PERMIT
SEWAGE DISPOSAL SYSTEM
 HOWARD COUNTY HEALTH DEPARTMENT
 BUREAU OF ENVIRONMENTAL HEALTH
 410-313-2640

P 514937-W

SUBDIVISION Monticello LOT NUMBER 21 ADDRESS 1749 Oakdale Drive

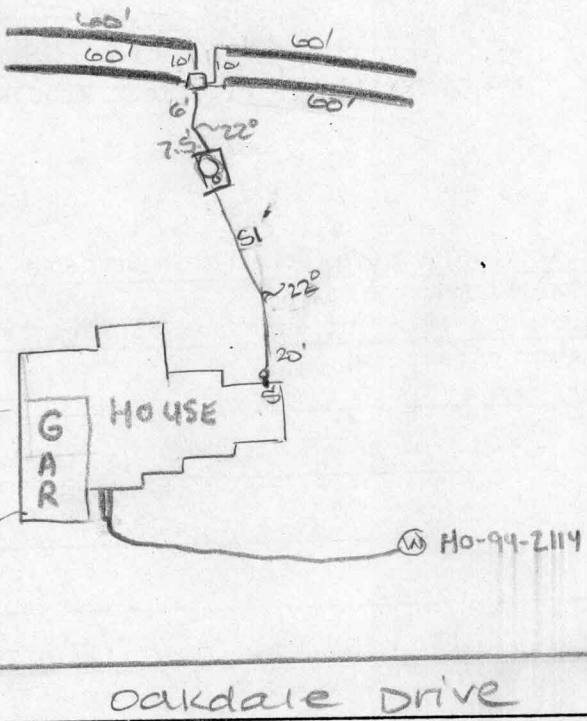
2/20/01 Layout anytime

2/21/01 necessary to use conn. all

2/21/01 - PM

PRE-CONSTRUCTION INSPECTION: 2/20/01 SDA staked - house plumbing to be raised to make correct d. box depth - OK to
 INSPECTION COMMENTS: continue. DKC
2/21/01 A.M. OK to continue work. DKC
2/21/01 P.M. OK to cover all septic work - Needs house connection verified prior to final approval. DKC
5/24/01 - HOUSE CONN. VERIFIED TO HAVE BEEN MADE (TALKED TO MARTY FROM DR HORTON) (SRW)

INSPECTOR Steven R. Krieg DATE SYSTEM APPROVED 5/24/01
